Work Order ID 106075

Item Name: Aft Crosstube - High

DRAWING NO. D412-664-243	TITLE CROSSTUBE ASS'Y (412 HI AFT)	REV. E	DART AEROSPACE LTD ENGINEERING ORDER		D.E.O. NO. D412-664-243-E-2	SHEET NO. SHEET 1 OF 1	SCALE NTS
DRAWN <i>q</i>	CHECKED <i>SS</i>	MFG. APPR. <i>RE</i>	APPROVED <i>MP</i>	DE APPR. <i>#</i>			
DATE 11.09.07	DATE 11.09.19	DATE 11.09.19	DATE 11.09.19	DATE 11.09.19

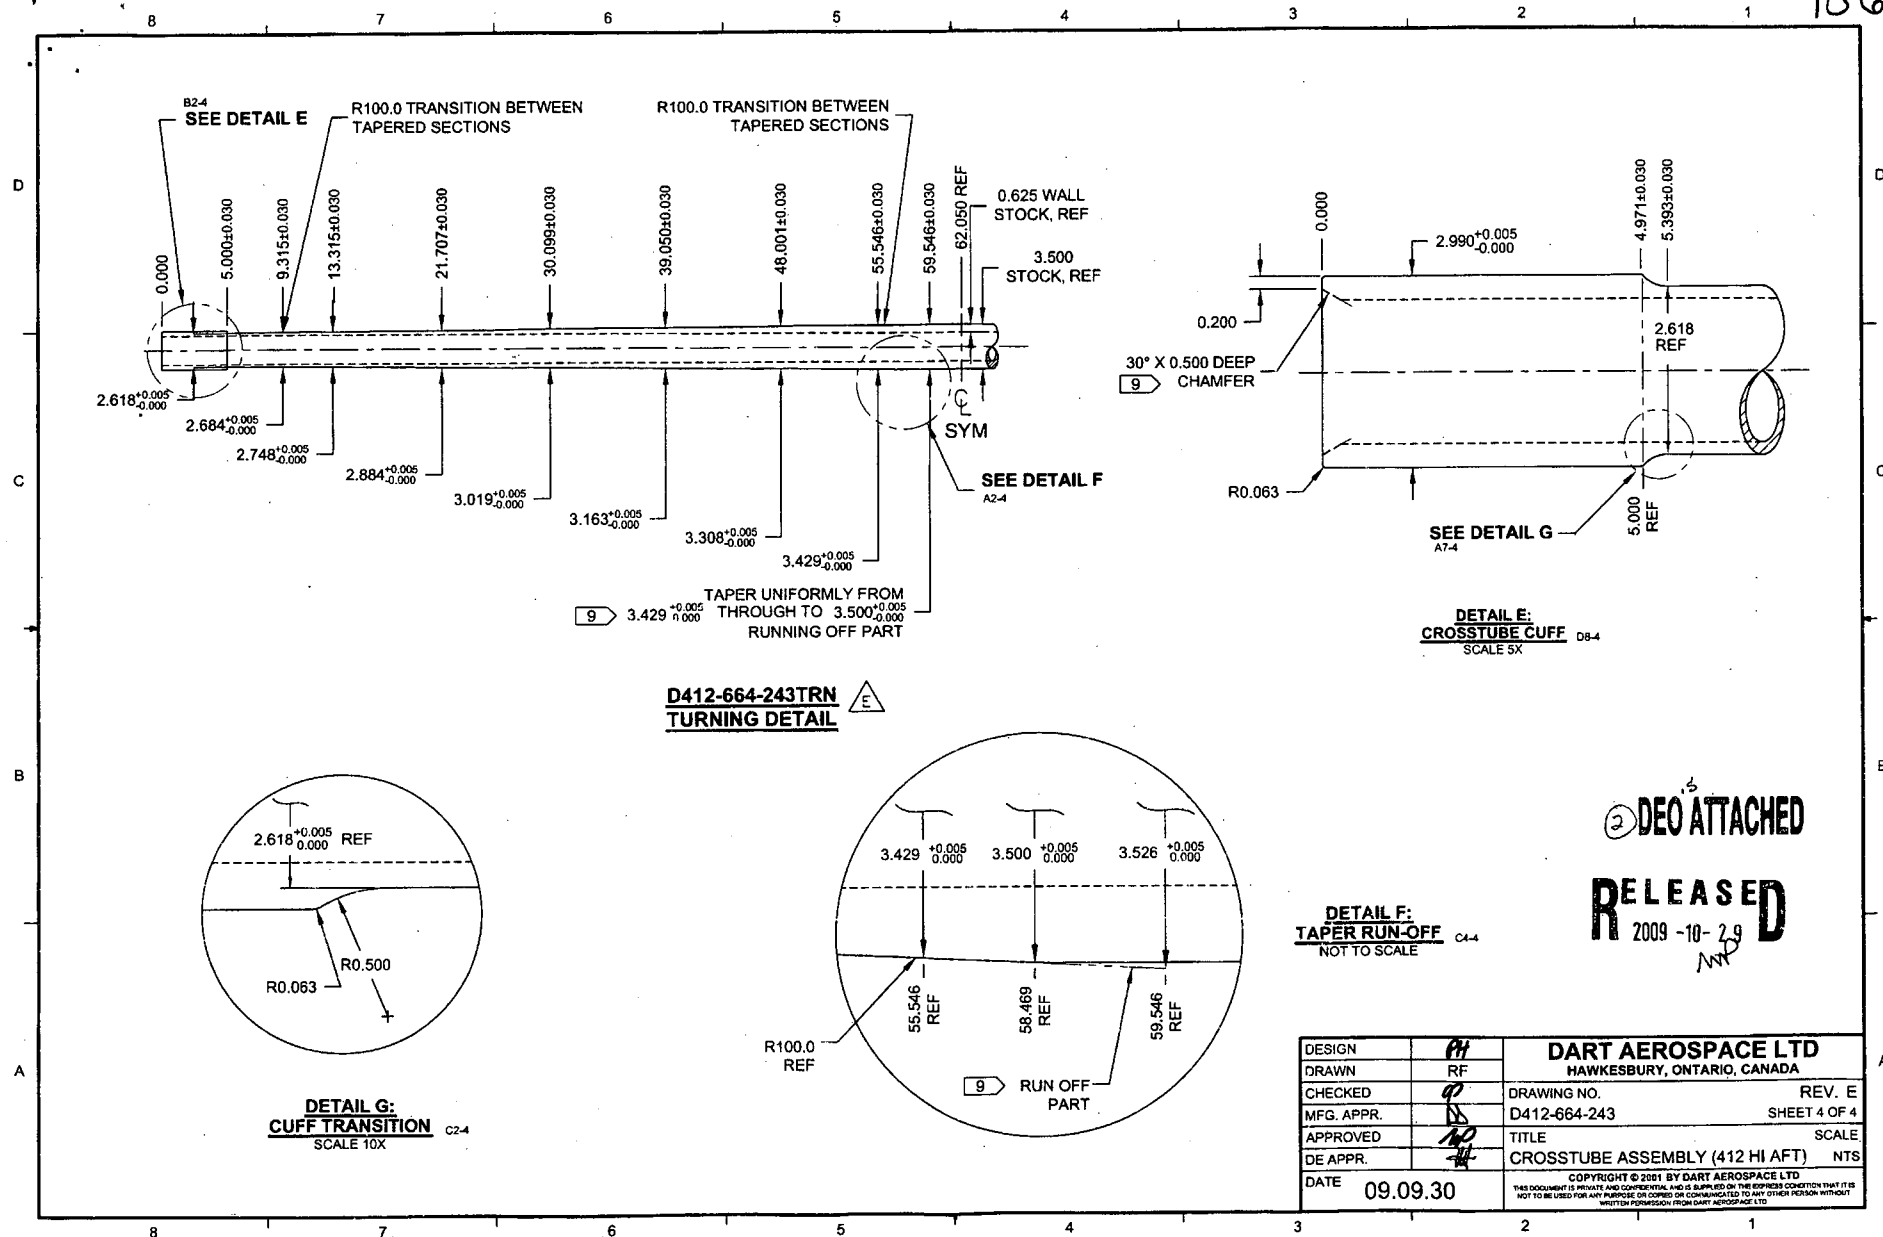
REPLACE MAGNOBOND WITH 3M DP460 SCOTCH-WELD EPOXY ADHESIVE

**D412-664-243
ASSEMBLY DETAIL**

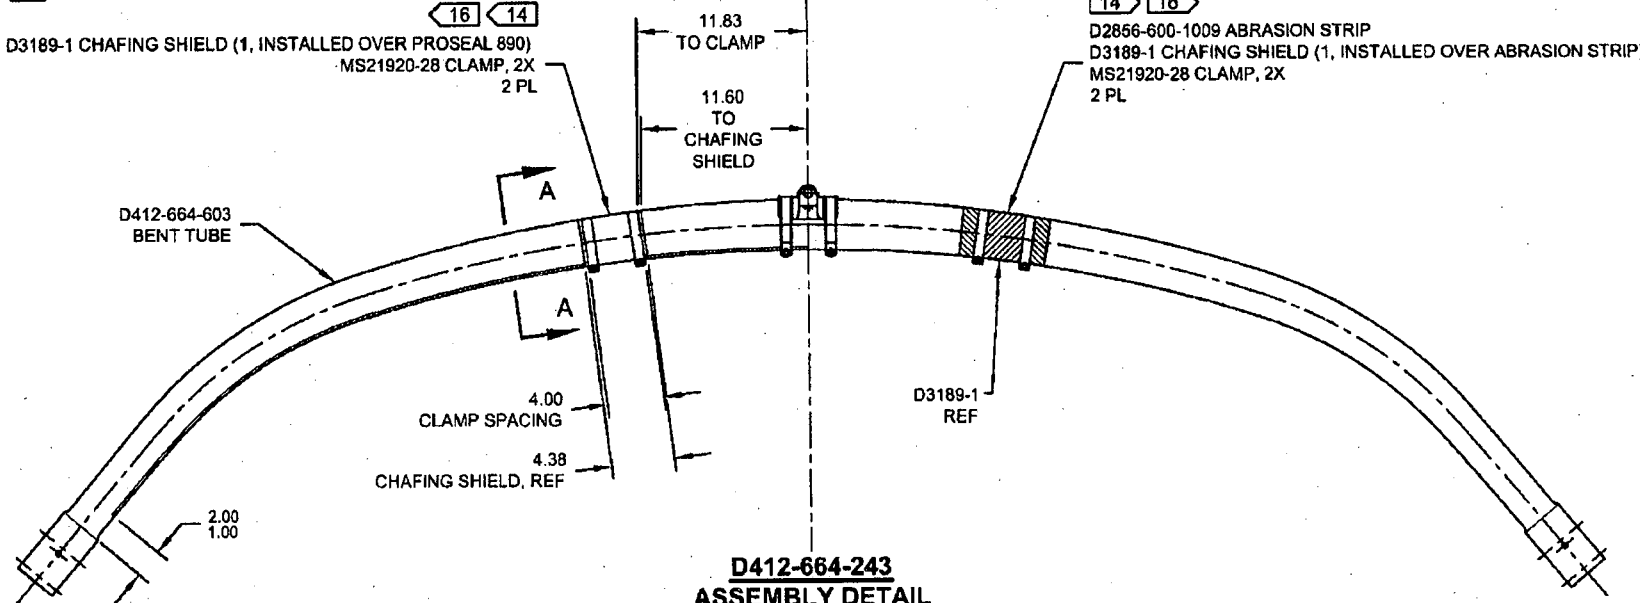
NOTES 2, 14, AND 16 ON SHEET 1 ARE AMENDED AS FOLLOWS:

IS:

D3189-1 CHAFING SHIELD (1, INSTALLED OVER PROSEAL 890)
MS21920-28 CLAMP, 2X
2 PL
